DONCASTER BEVERLY DANBURY RECONSTRUCTION

ASSESSMENT DISTRICT - 2024

CITY PROJECT NO. 14079
CONTRACT NO. 8709

REVISION #1- 8/15/2024
REVISED THE FOLLOWING:
EC4, EC6, G11, G13-G15, PD2-PD6, P2-P6, U4-U5, W1, X4-X5, X7, X9, X12

14079		BY	...
	EC-3		DATE	...
	14079		REVISION	...
BEVERLY ROAD - EROSION CONTROL DONCASTER BEVERLY DANBURY RECONSTRUCTION		14079 MADISON, WI 8709 CONTRACT NO.:		Scale: 1" = 40' Date: 5/9/2024 2:58 PM 14079 EC-3

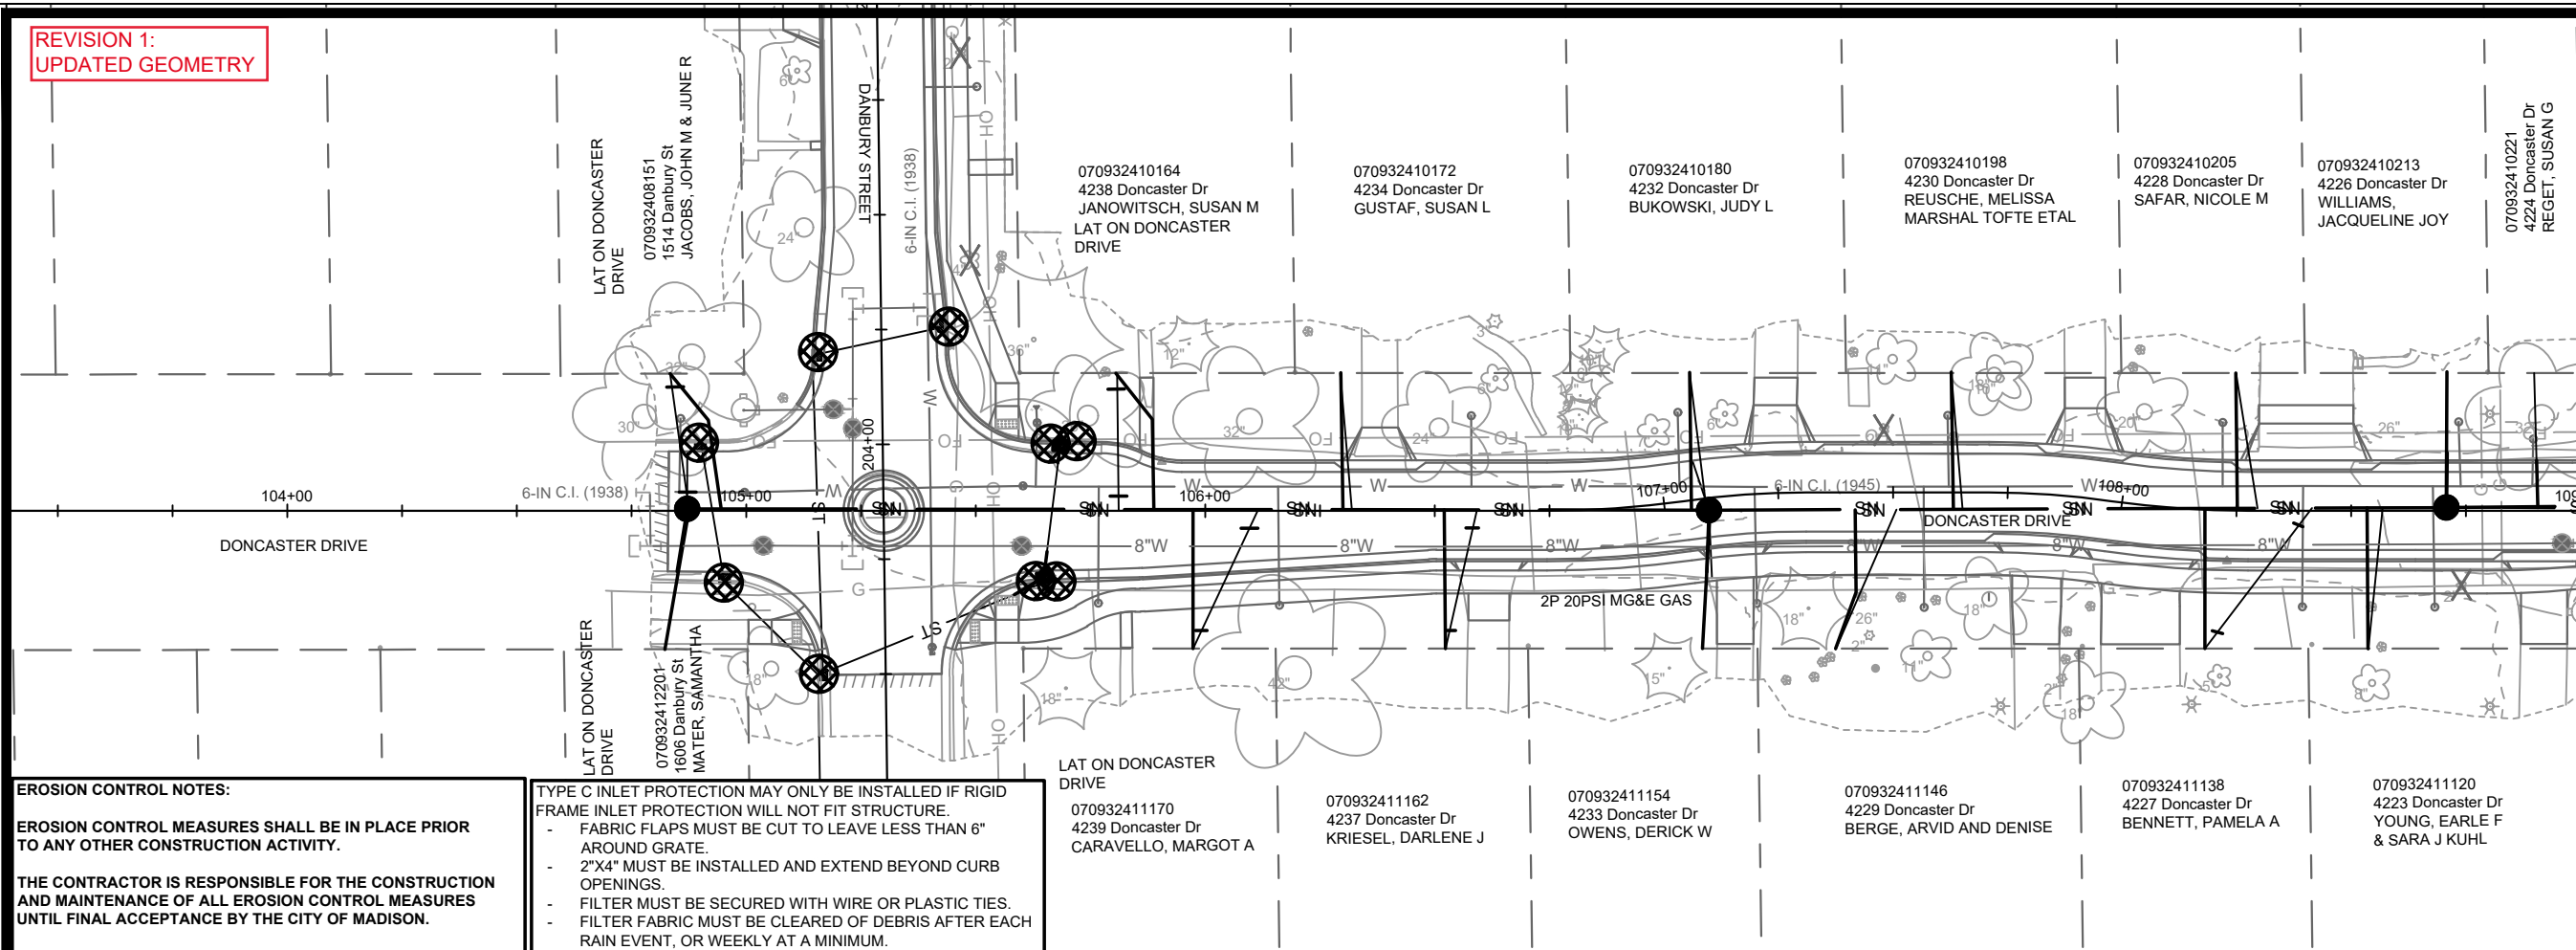
REVISION 1:
UPDATED GEOMETRY

14079	MADISON, WI	8709	CONTRACT NO.:
DANBURY STREET - EROSION CONTROL			
DONCASTER BEVERLY DANBURY RECONSTRUCTION			
M:\DESIGN\Projects\14079\CAD\Sewers\14079SWR-Erosion Control.dwg			
14079		EC-6

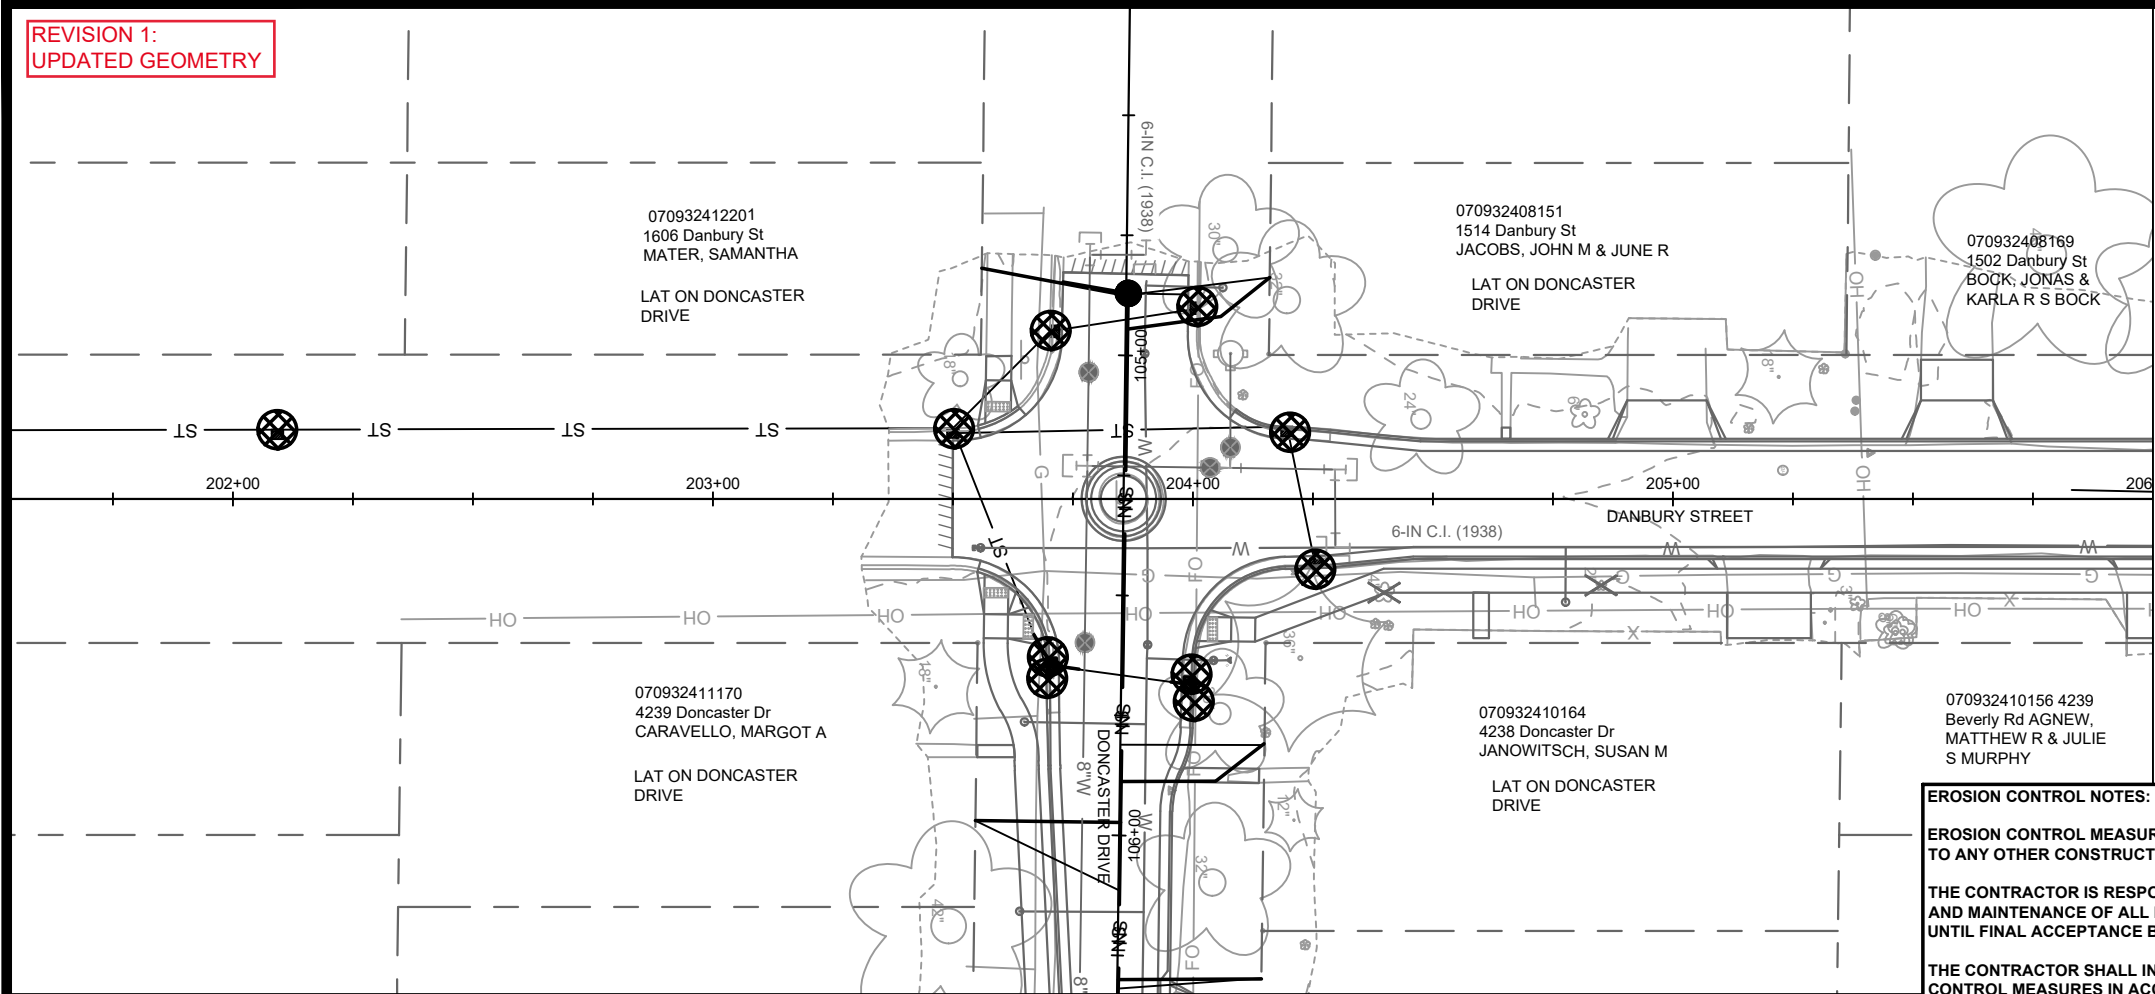
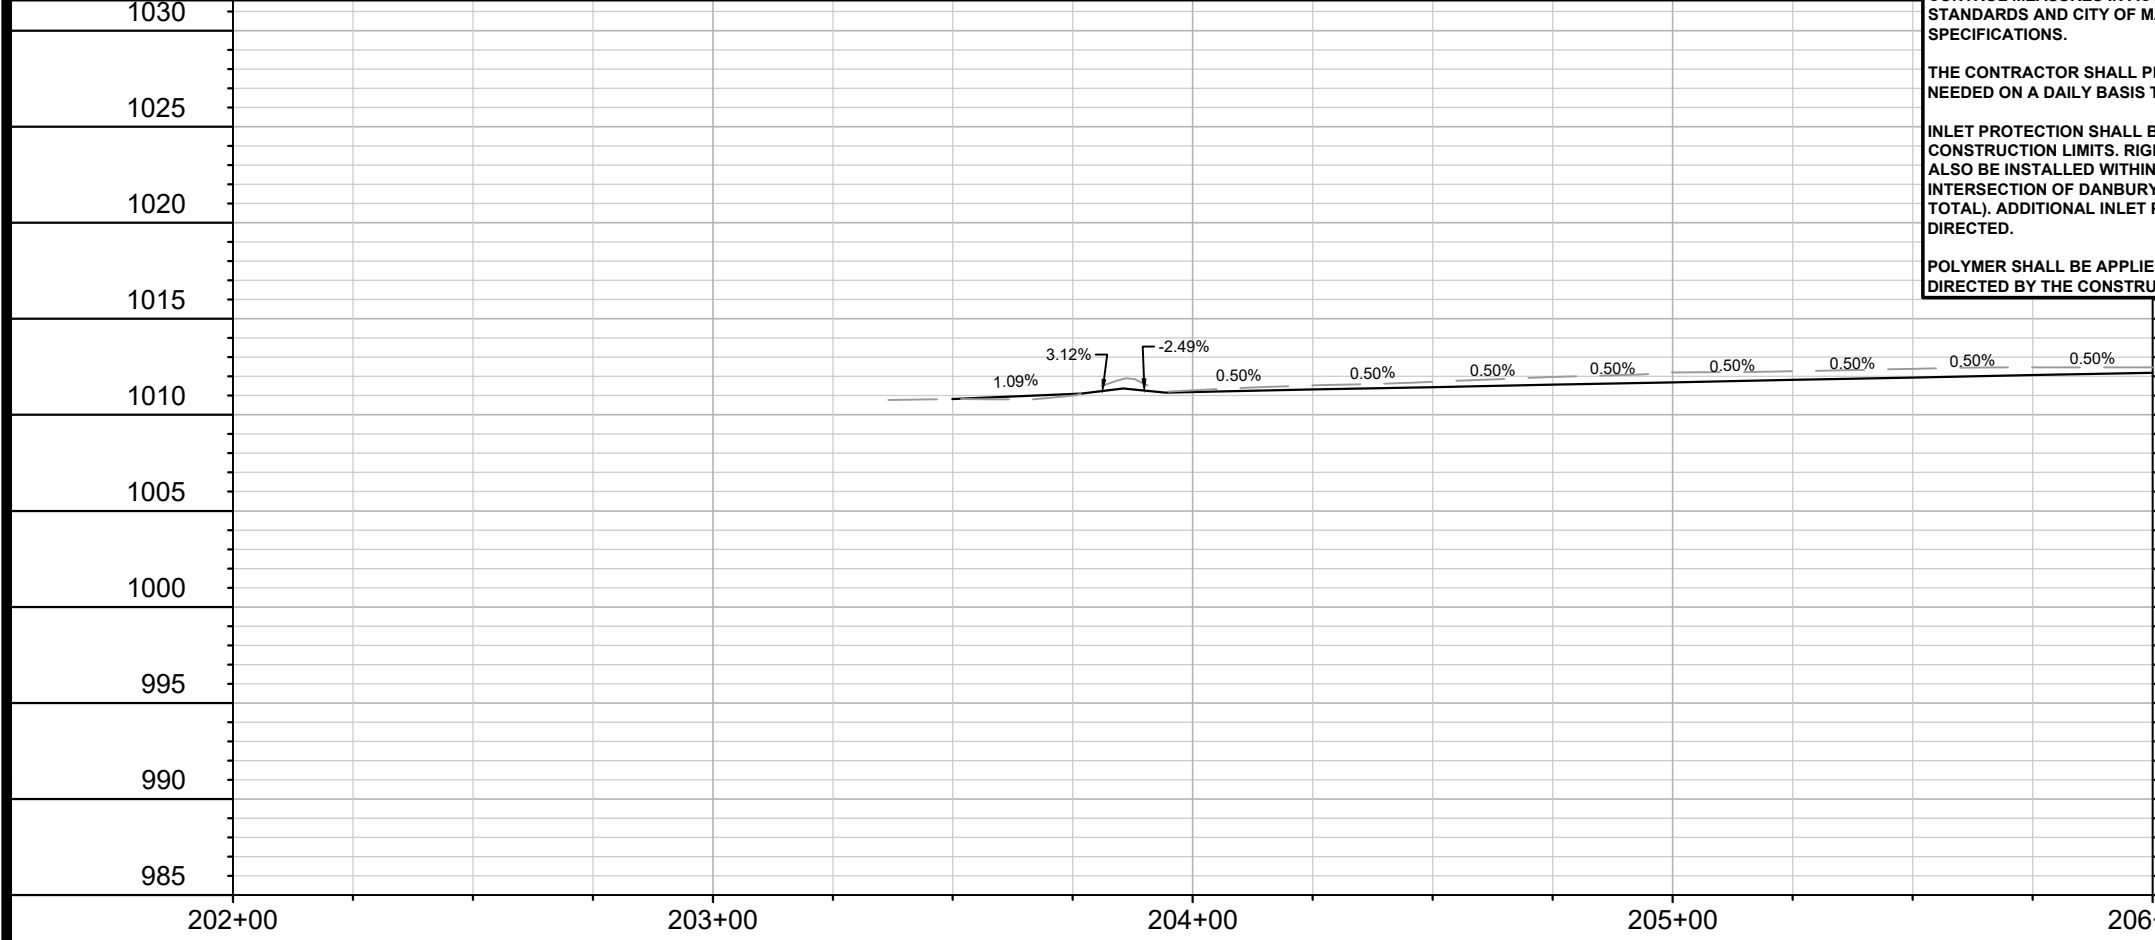
REVISION 1:
UPDATED GEOMETRY

EC-7

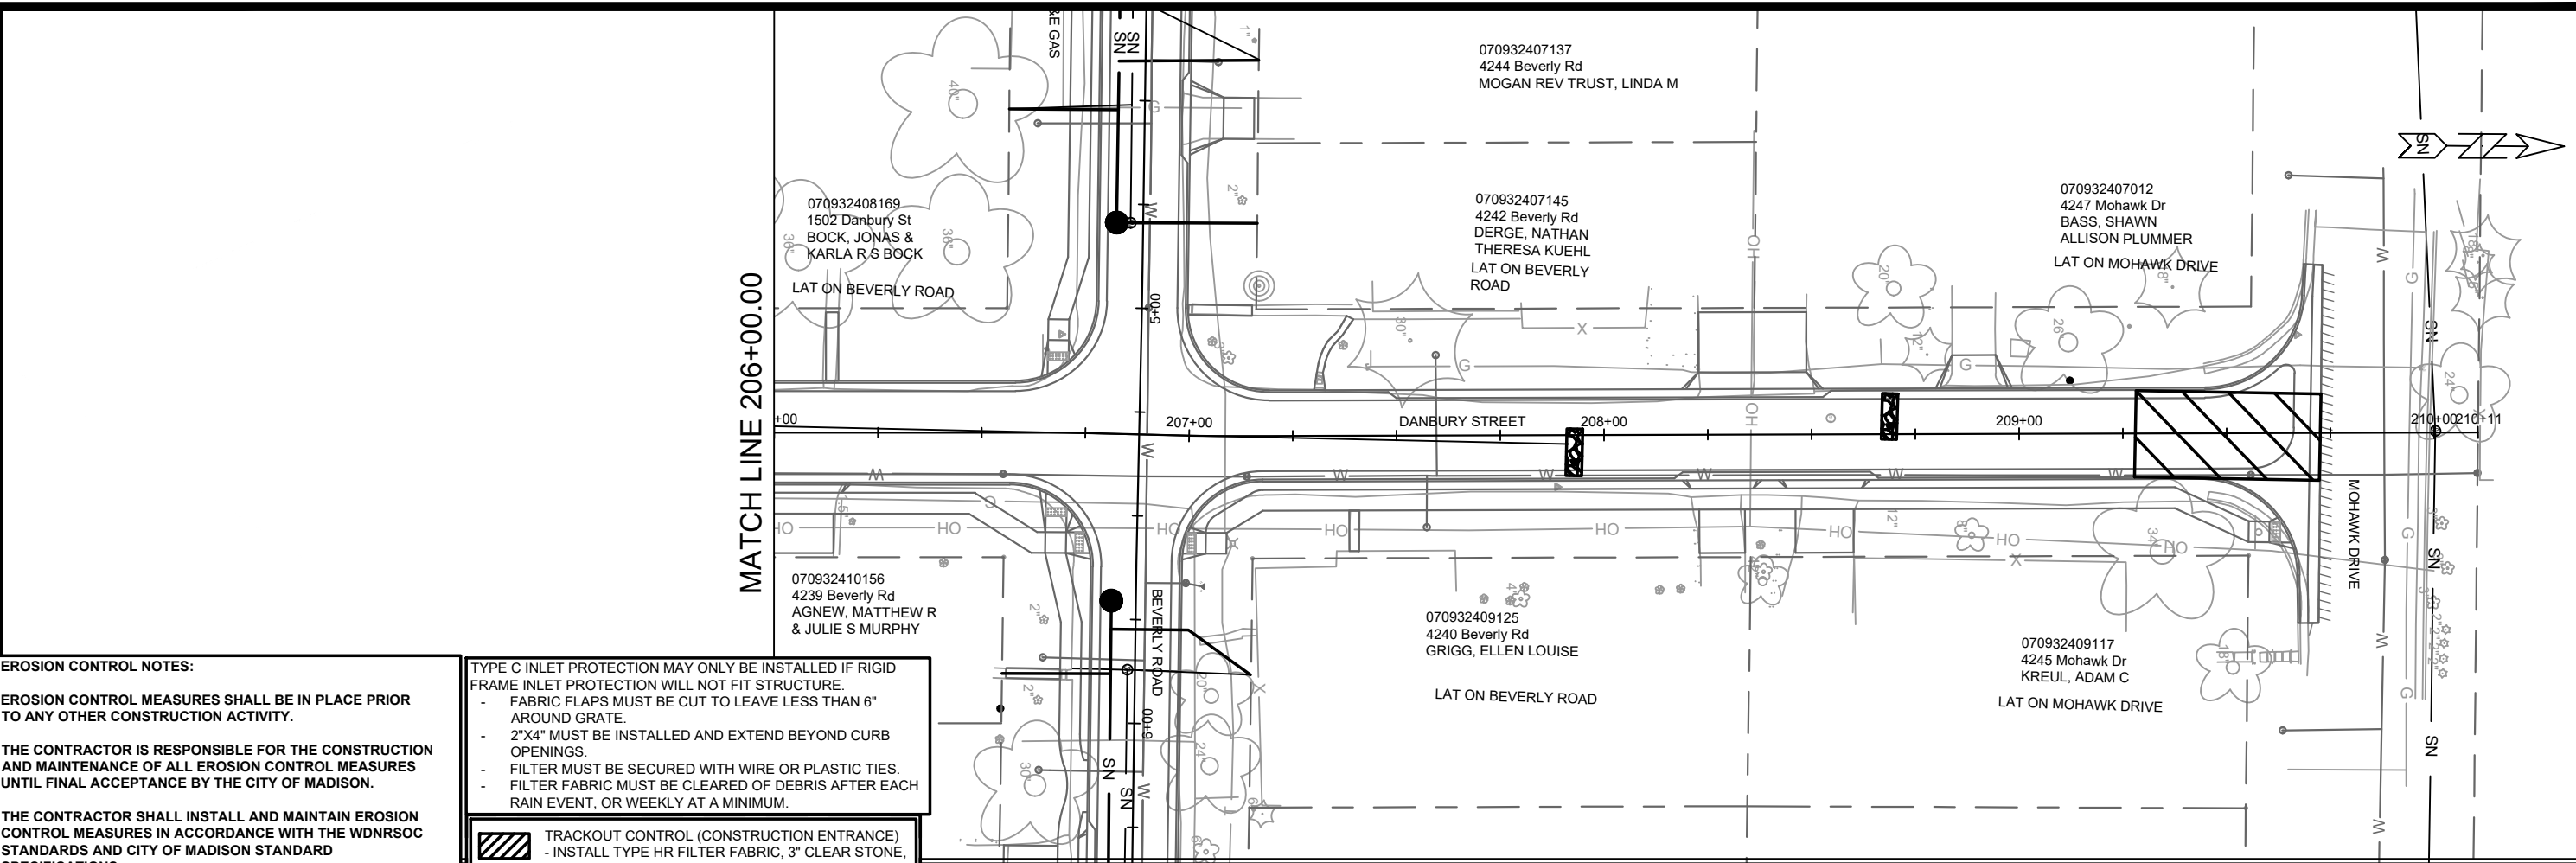
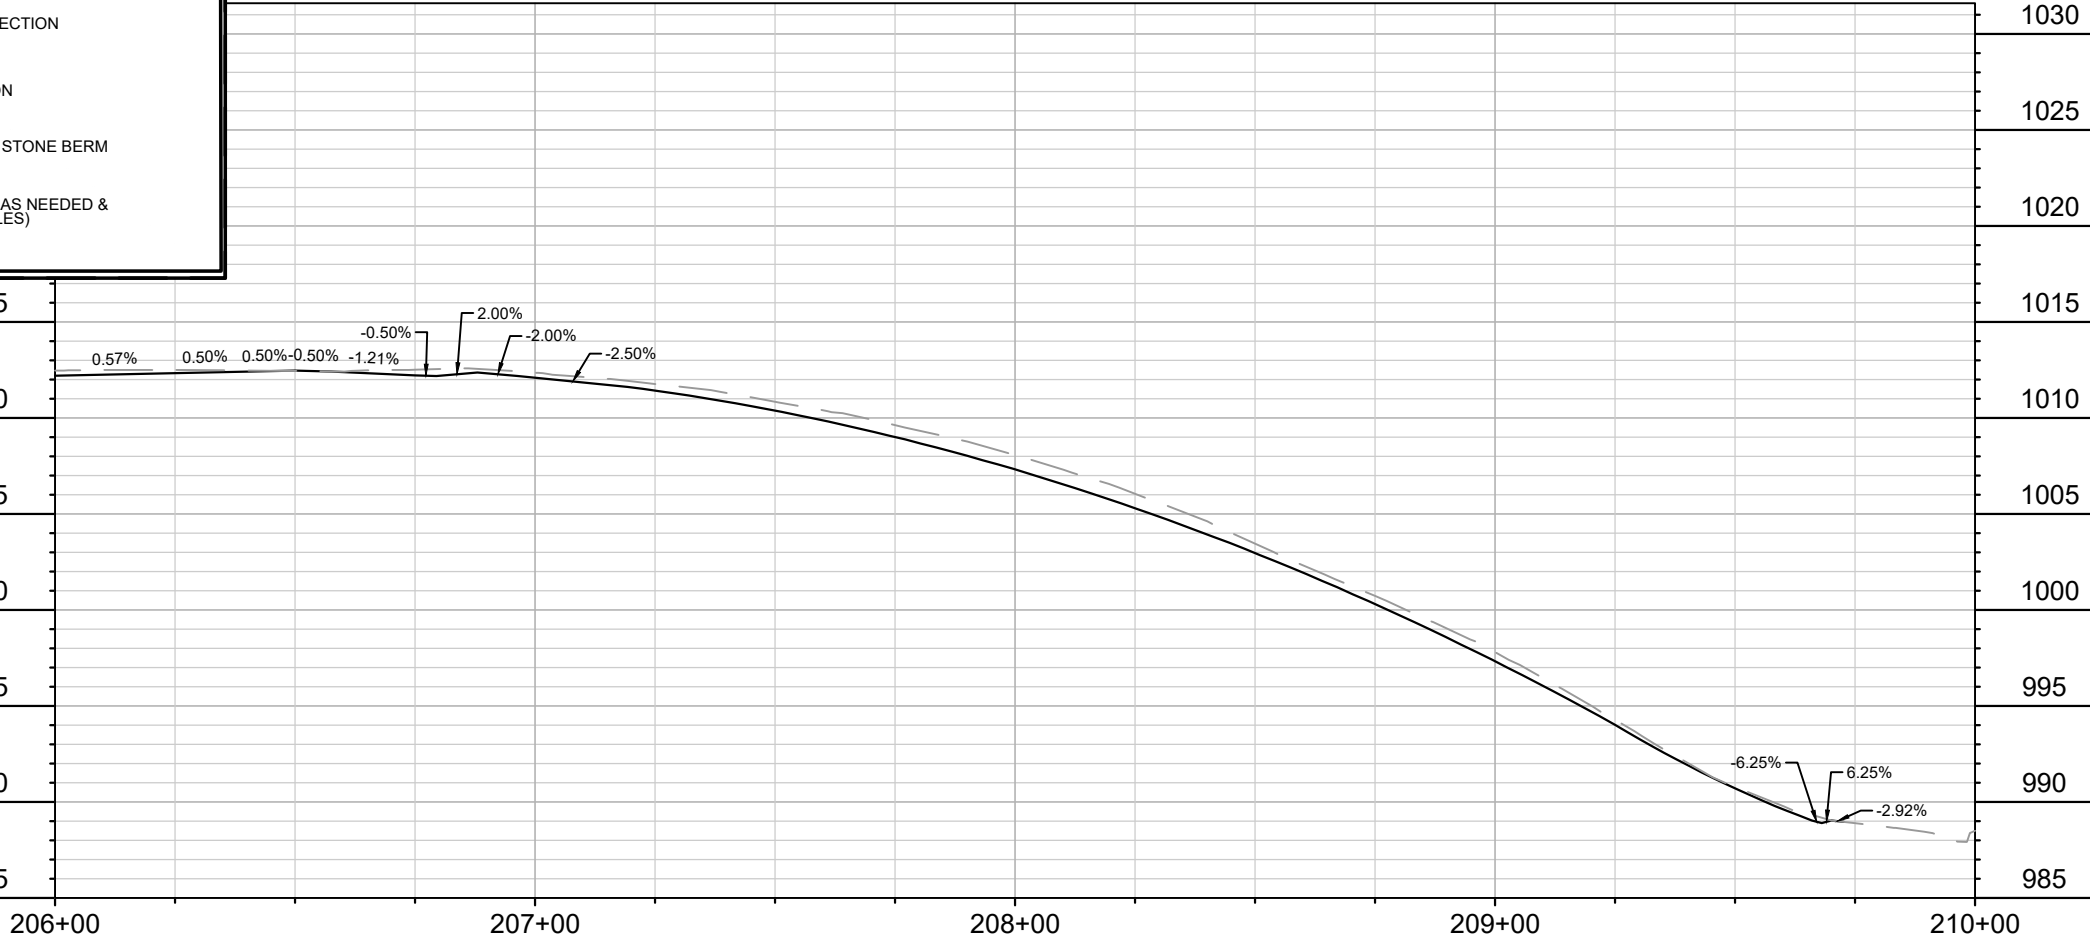
REVISION 1:
UPDATED TO
NEAREST ALIGNMENT
